Product Change Notification / SYST-08DHB472

ERRATA - PIC18F26/46/56Q84 Silicon Errata and Data Sheet Clarifications

PIC18F26/46/56Q84 Silicon Errata and Data Sheet Clarifications

1.6.1 UART TXDE Signal May Go Low Before the STOP Bit Has Been Entirely Transmitted

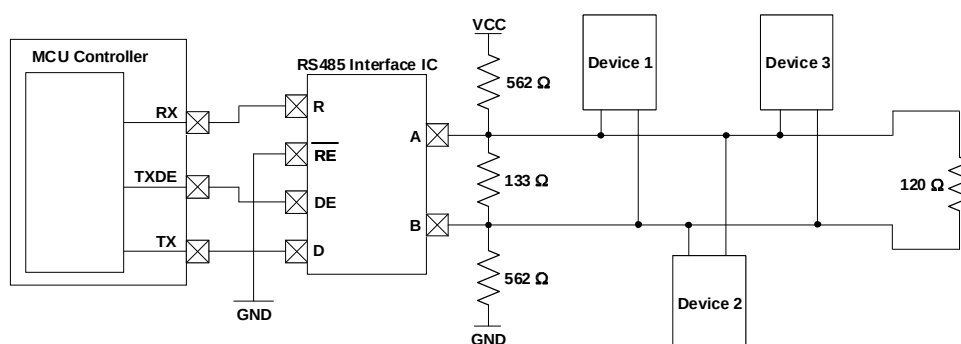
The UART Transmit Drive Enable (TXDE) signal could potentially transition into a low state before the UART STOP bit has been entirely transmitted due to the effects of parasitic capacitance on the TX line. In some applications, this could result in communication being prematurely terminated due to the TXDE bit going low before the STOP bit has had enough time to settle.

To ensure that the STOP bit settles into its final logic state before the TXDE signal transitions low, a biasing circuit can be implemented. A biasing circuit allows the TX line to either be driven high or low, rather than being left in a floating tri-state mode where prolonged rise or fall times could lead to communication being disrupted. This bias circuit should only be implemented on one end of the serial bus, and a termination resistor should be used on the other end. The figure below show an example of a bias circuit that can be used to achieve this.

Please note that the resistor values used in this circuit are recommendations, and that the actual resistor values required may vary based on the application.
